ADDENDUM NO. 1

DNR-250004 GREAT COUNCIL OBSERVATION TOWER

1587 US-68,
Xenia, OH 45385

1 Floor Plan - New Work
1/4" = 1'-0"

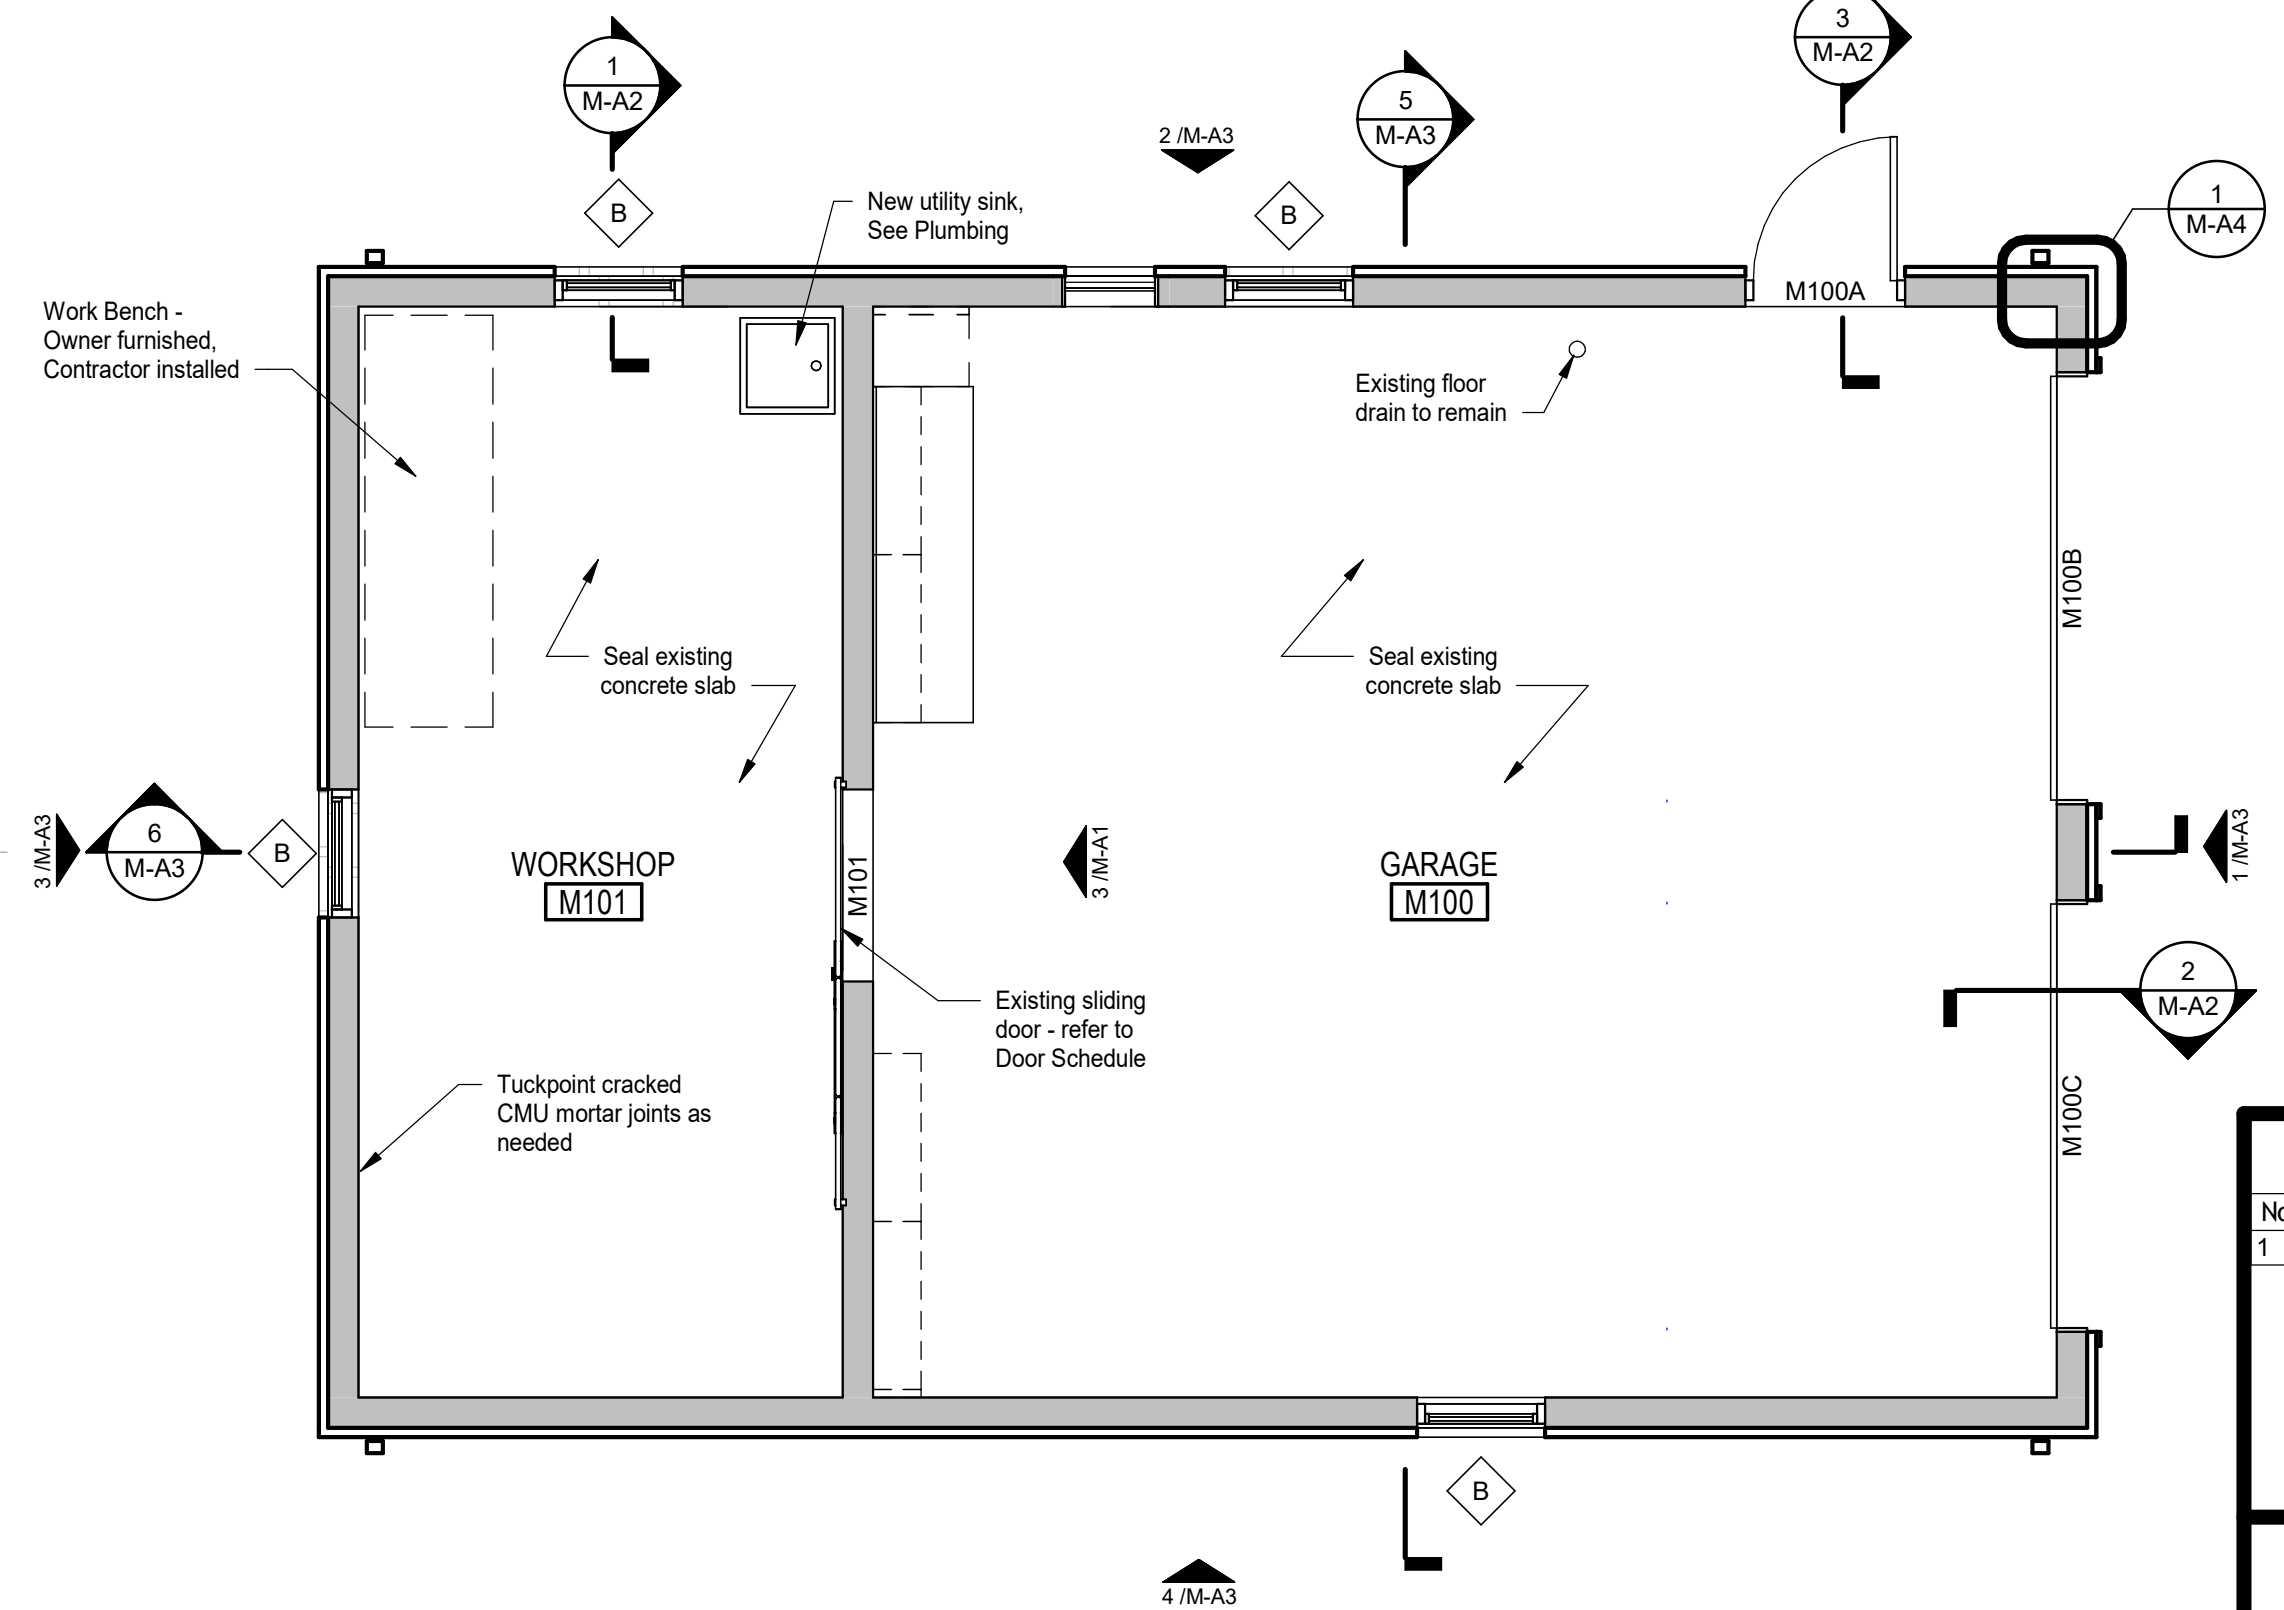
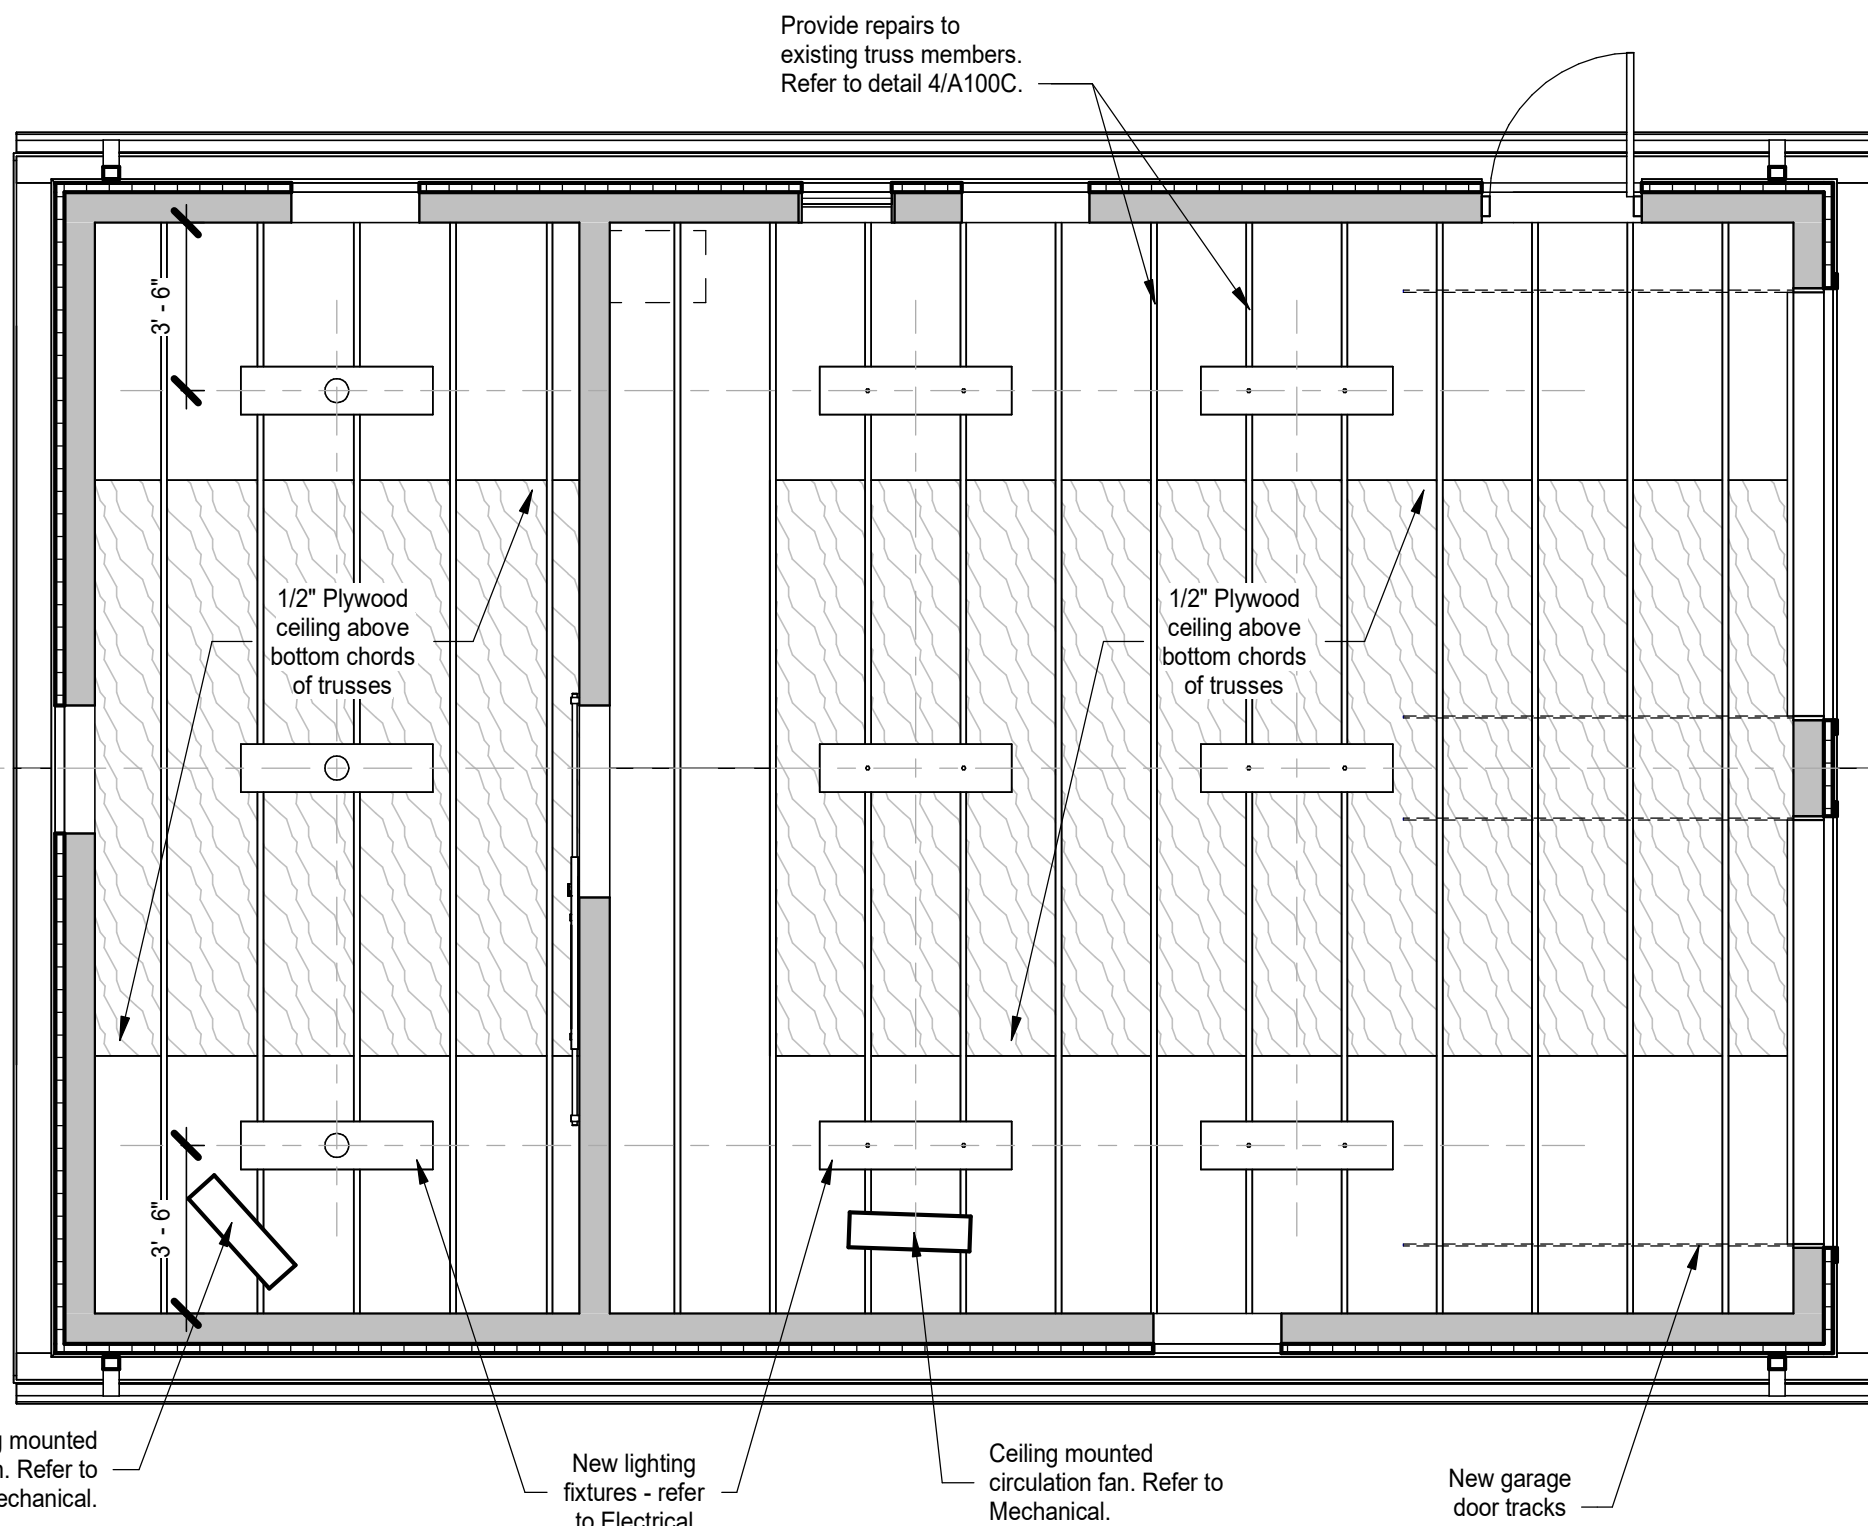
ITEM 8 M-A1 – FLOOR PLANS AND INTERIOR ELEVATIONS

Revised casework keynote to manufactured metal casework.

Tower Floor Plan

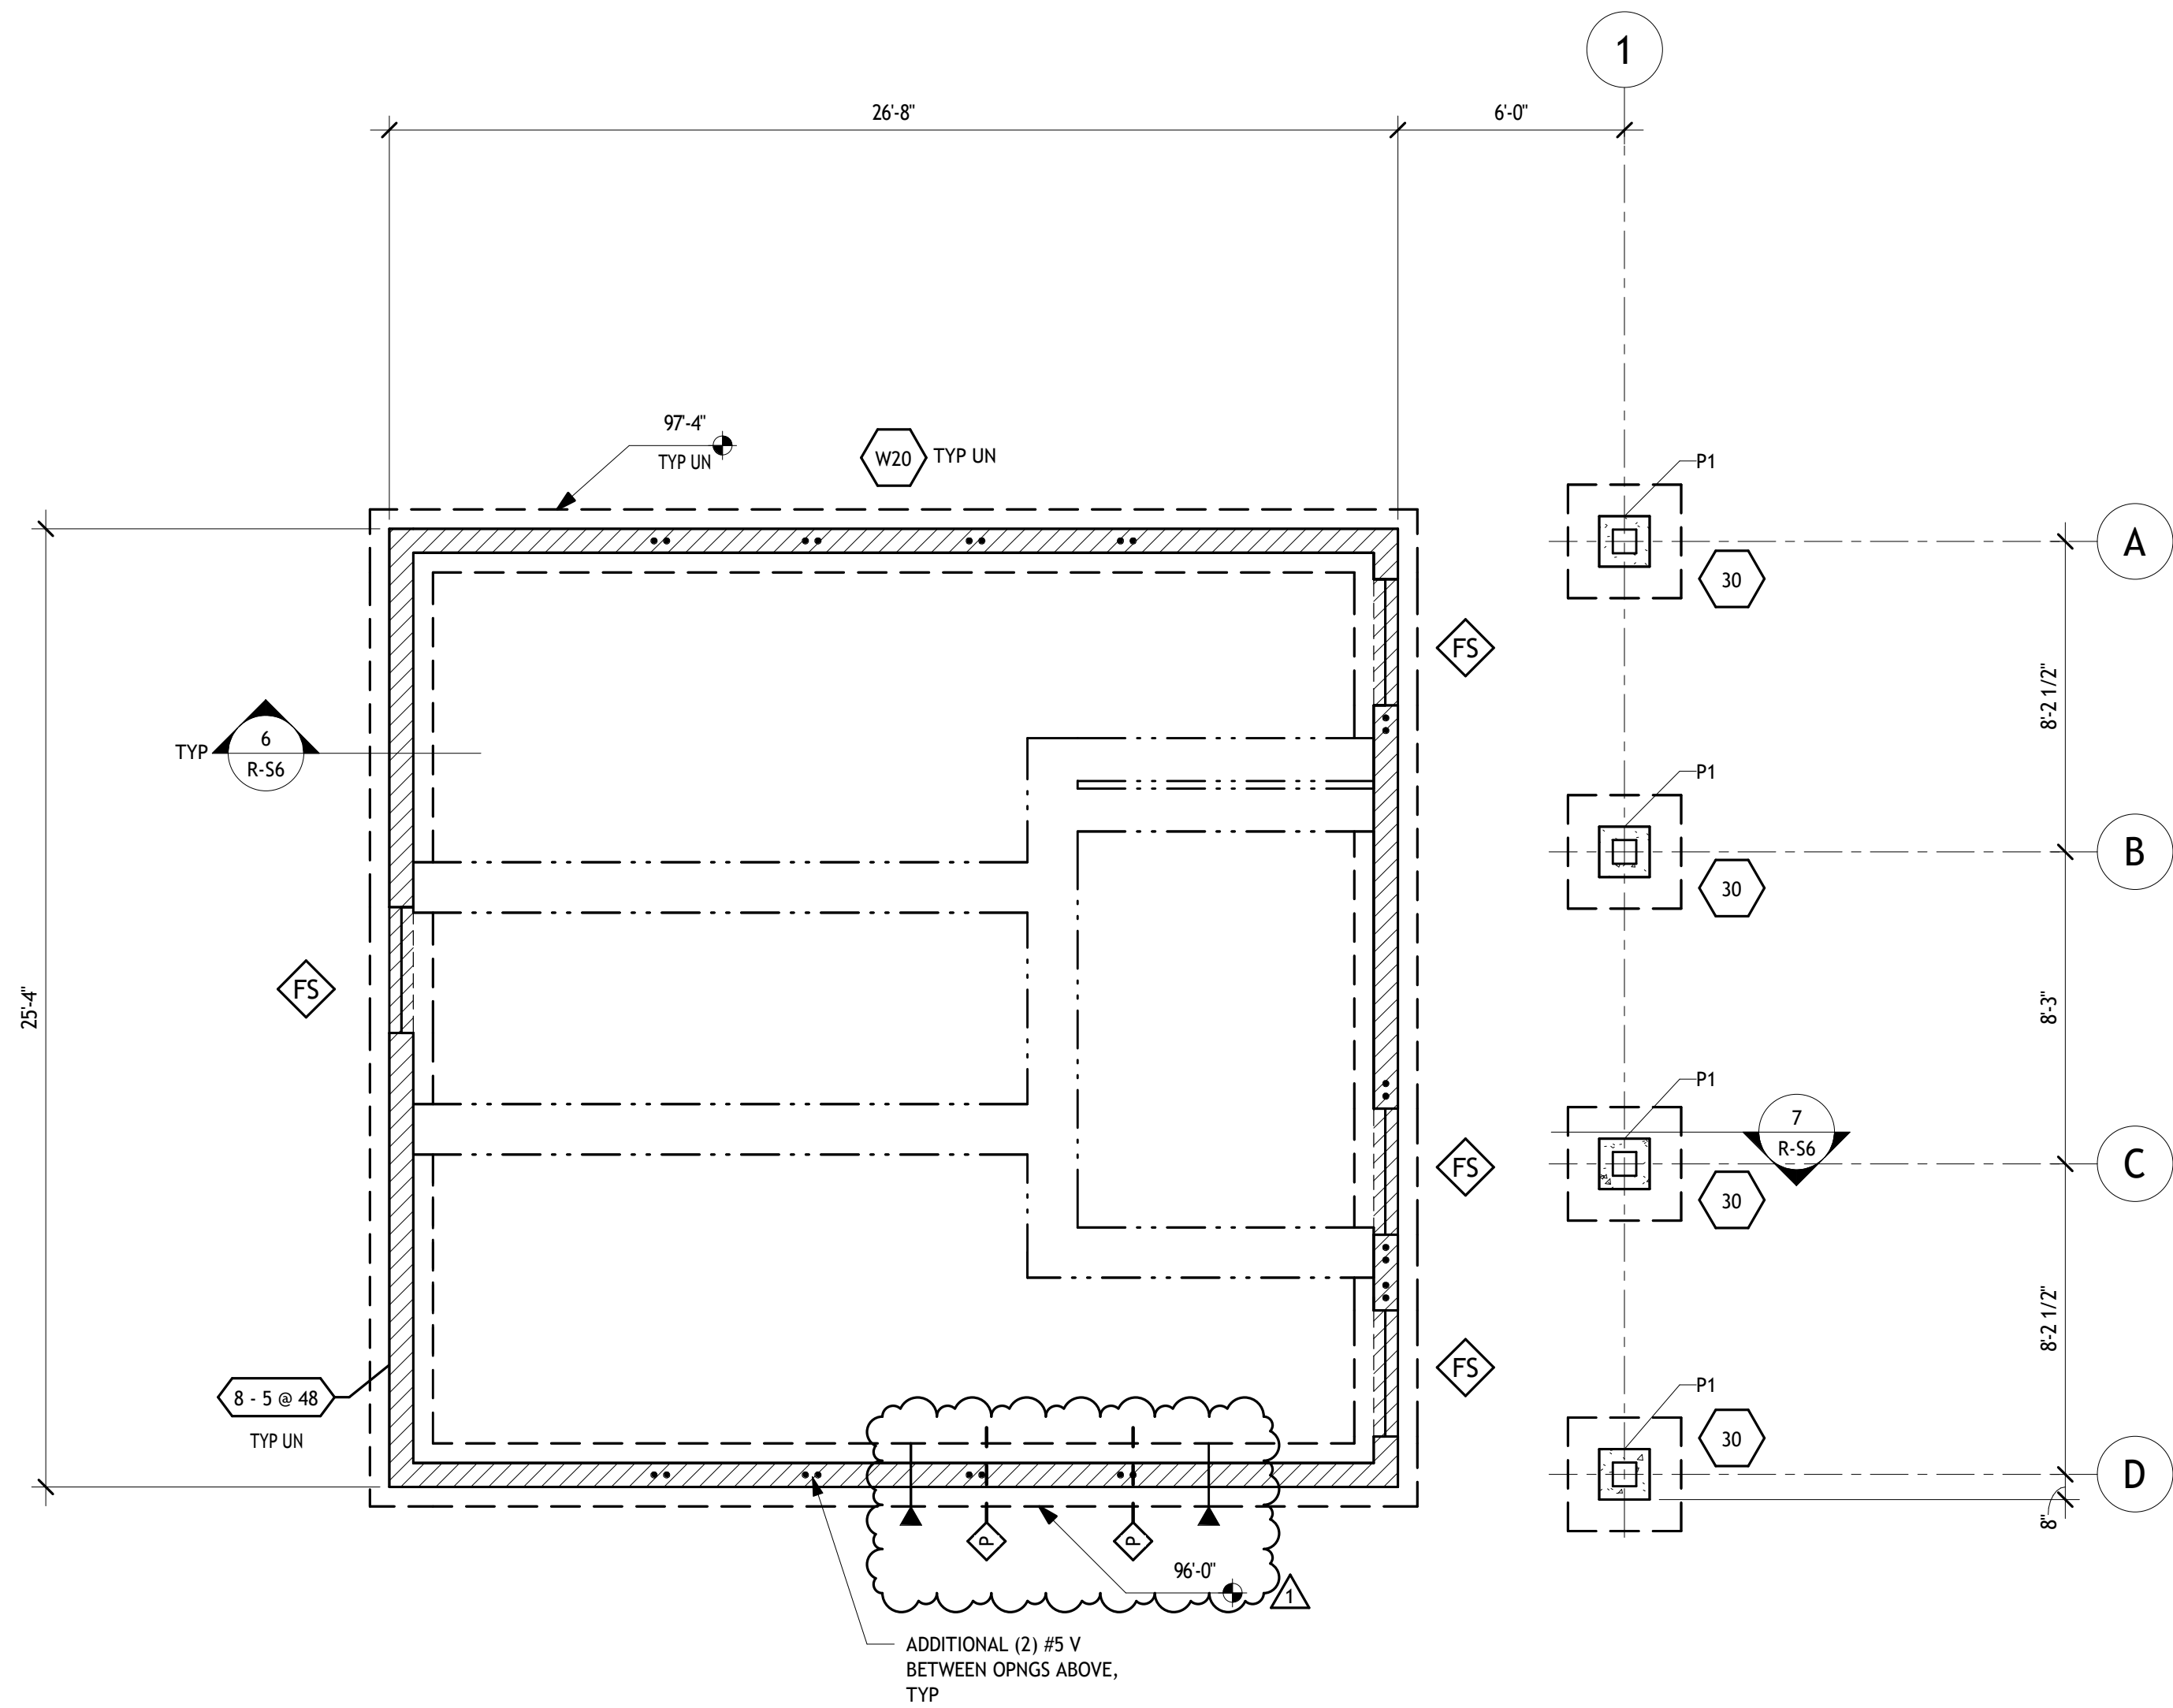
ITEM 12 T-A1 – TOWER FLOOR PLAN

Revised layout of platform decking to coordinate with floor joist orientation.
